# **FREDERICK COUNTY PLANNING COMMISSION**

## **November 13, 2013**

**TITLE:****Sonic Restaurant****FILE NUMBER:****SP-97—36A, AP #13781****REQUEST:****Site Plan Approval**

The Applicant is requesting site plan approval for a 1,704 square foot restaurant with drive through lanes and outdoor seating, on a 1.04-acre site.

Graphic #1

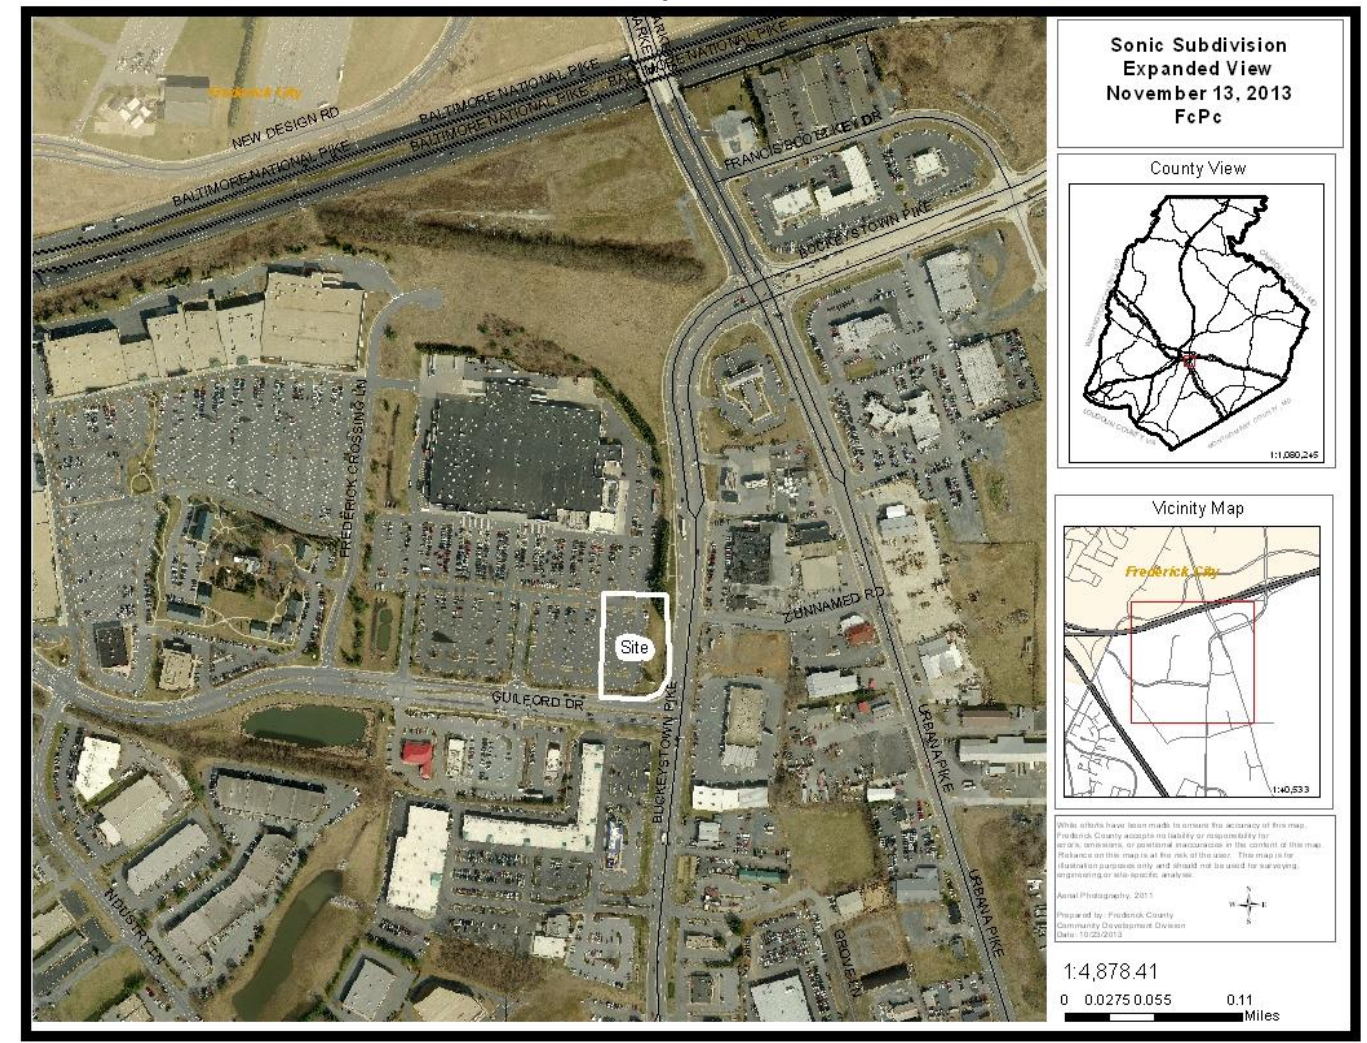
The Applicant is requesting site plan approval for a 1,704 square foot restaurant, with drive through lanes and outdoor seating for 40 people, the use will also contain 21 covered drive-up parking service stations. The restaurant will be located within the existing Wal-Mart parking lot at the corner of Guilford Drive and MD 85 (See Graphic #1). The Applicant is also proposing 39 parking spaces, including 2 handicapped accessible spaces. The proposed use is being reviewed as a "Restaurant" land use under the heading of *Commercial Business and Personal Services* per §1-19-5.310 Use Table in the Zoning Ordinance and is a principal permitted use in the General Commercial Zoning District subject to site development plan approval.

Graphic #2

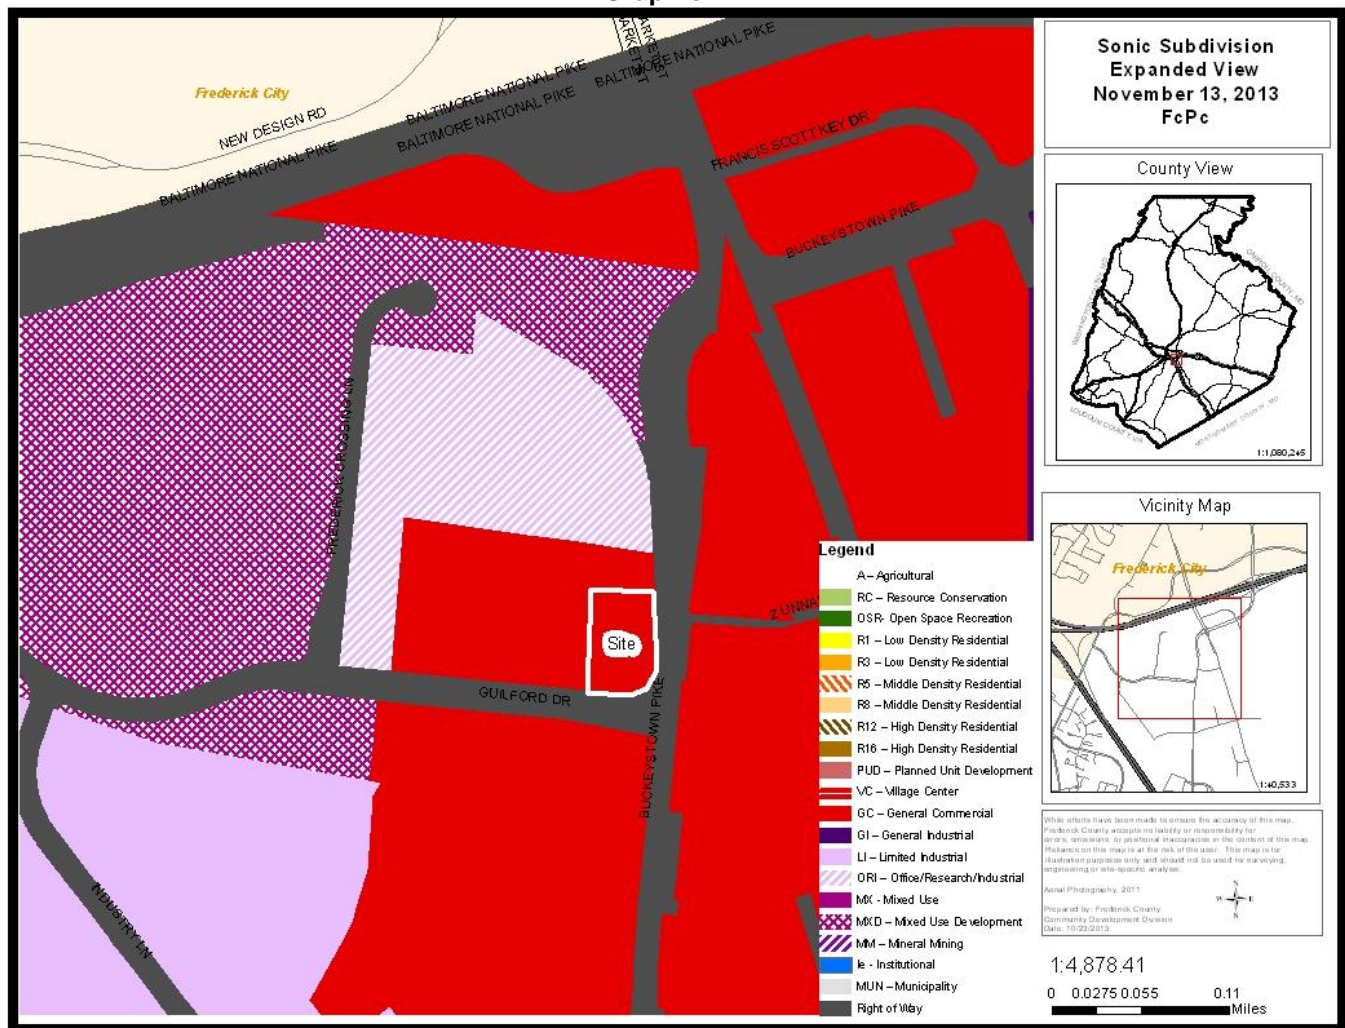
The site is currently zoned General Commercial, and is developed as parking for the existing Wal-Mart Retail Store (See Graphic #2). The property to the west of the site is developed with the Frederick Crossing Retail Center, with associated parking spaces.
